Intel[®] 80331 I/O Processor

Specification Update

April 2006

Table 236. DDR SDRAM Control Register 0 - SDCR0 (Sheet 1 of 2)

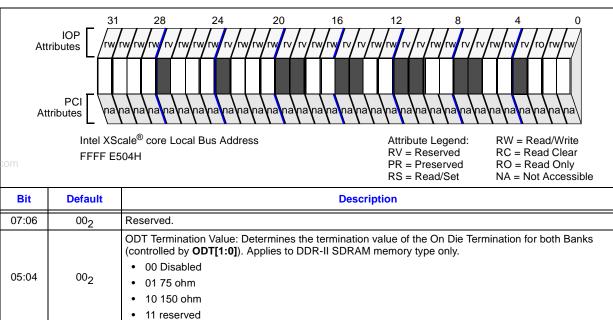
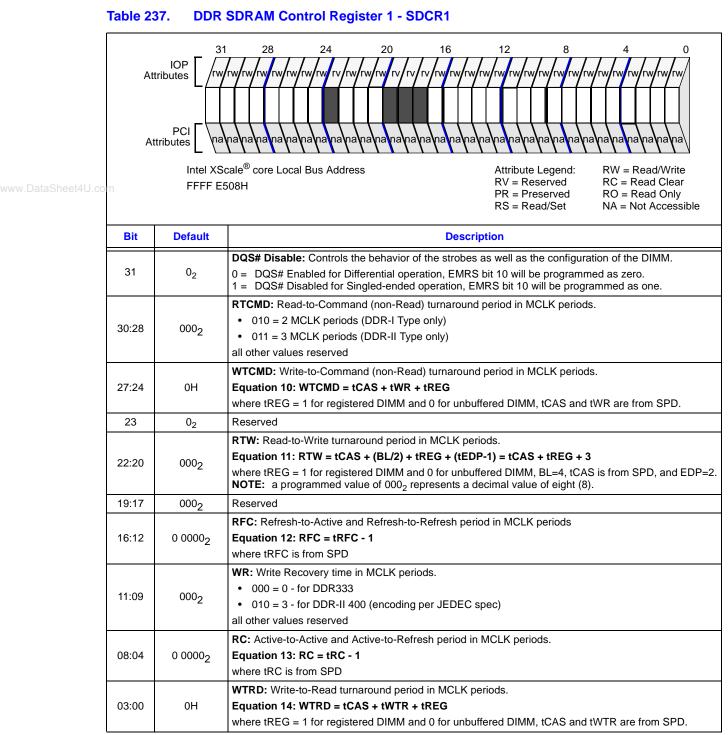
Workaround:
